September 4, 2025

Subject: ADDENDUM No. 5, RFT 2025-011
Novar Covered Rink

DRAWING A-5
SECTION 8 — REVISED
SCALE NTS

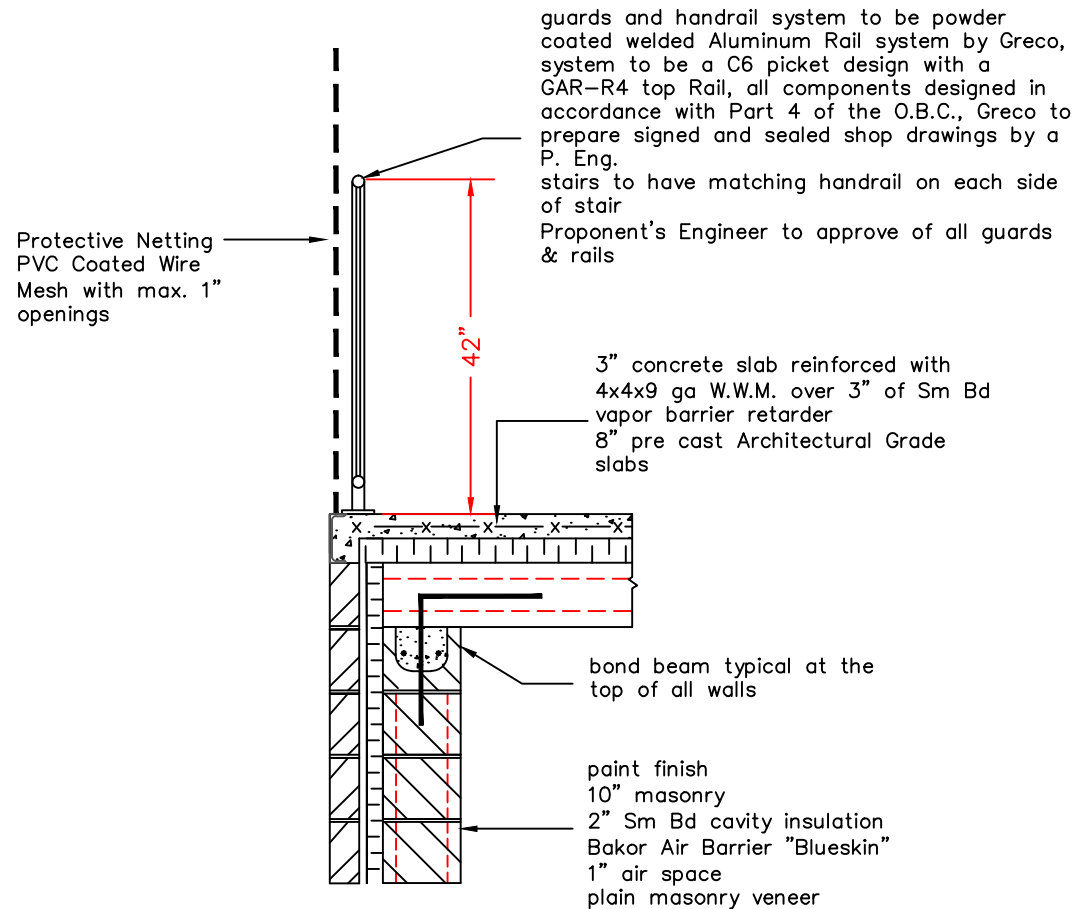
1. *Section 8/A-5 and Section 1/A-5 contravene each other for the wall above the mezzanine. Please clarify which is to be used.*

The Section 8 is an exterior wall and Section 1 is an interior wall. Section 8 has been revised to show the railing assembly and PVC coated wire mesh (revised drawing attached).
